# Access Compliance Report

## Public Rights-of-Way

### (Curb Ramps)

Intersection ID: 14086	Main Street: BALDWIN_AV	Cross Street: E_3RD_ST	Location:	N
ADA ID: CF172827FBA8	Ramp Type: Perp	Initial Pass/Fail: Fail	Overall Compliance: No	Severity Score: 22.5
Codes/Mitigation Info/Possible Solution		Field Measurements/Component Compliance

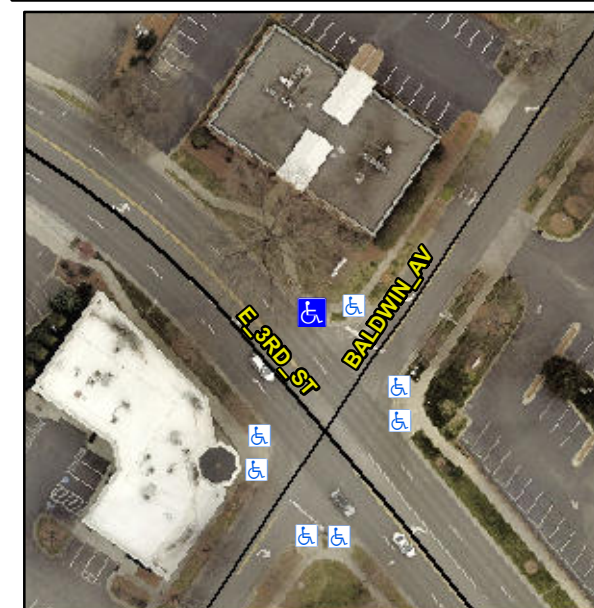
**Not Found, R304.5.1, R304.2.2, R304.5.3**

Compliance	Description	Data	Compliance	Description	Data
N/A	Ramp Length (in)	46.5	No	Ramp Slope (%)	9.4
No	Ramp Width (in)	42.5	No	Ramp XSlope (%)	2.1
N/A	Flare Type LT	N/A	N/A	Flare Type RT	N/A
N/A	Flare Slope LT (%)	N/A	N/A	Flare Slope RT (%)	N/A
N/A	Flare Traversable LT?	N/A	N/A	Flare Traversable RT?	N/A
N/A	Landing Length (in)	N/A	N/A	DWS Provided?	N/A
N/A	Landing Width (in)	N/A	N/A	DWS Contrast?	N/A
N/A	Landing Slope (%)	N/A	N/A	DWS Length (in)	N/A
N/A	Landing X Slope (%)	N/A	N/A	DWS Full Width?	N/A
N/A	Landing Curb? (Y/N)	N/A	N/A	DWS Offset (in)	N/A
N/A	Shared Landing?	N/A			
N/A	Gutter Ponding?	N/A	N/A	Gutter Slope (%)	N/A
N/A	Gutter Lip Ht (in)	N/A	N/A	Gutter X Slope (%)	N/A
N/A	Painted X Walk1?	No	N/A	Painted X Walk2?	N/A
	X Walk 1 Direction	To SW		X Walk 2 Direction	N/A
N/A	X Walk 1 Width (in)	N/A	N/A	X Walk 2 Width (in)	N/A
	X Walk 1 Slope (%)	1.8		X Walk 2 Slope (%)	N/A
	X Walk 1 X Slope (%)	1.3		X Walk 2 X Slope (%)	N/A

**Remove & Replace Entire Ramp.**
